REMARKS

In the Drawings

The Rejection of Claims 1, 9, 13, 14, 17, 25, 29 and 30 under 35 U.S.C. 102(b)

Fig. 1

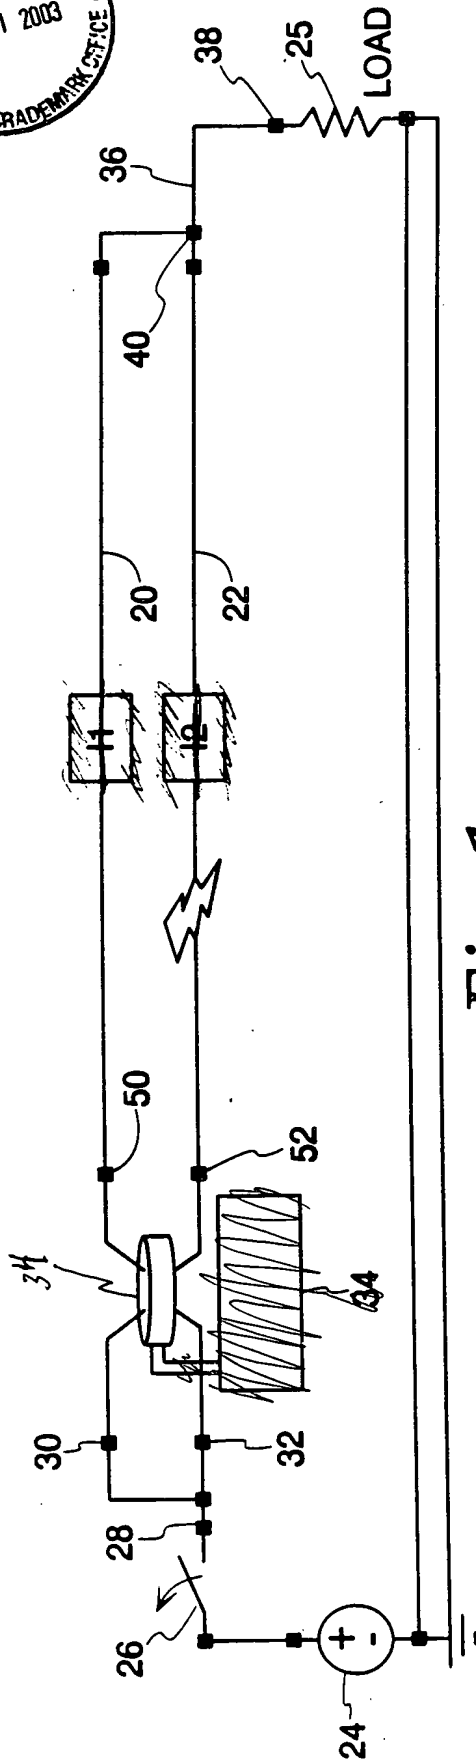
The Examiner objected to the drawings because they did not have sufficient labels; specifically boxes 34, 34A, 43 and 35 were cited. The blank boxes in the drawing have been descriptively labeled in the proposed drawing amendments submitted herewith.
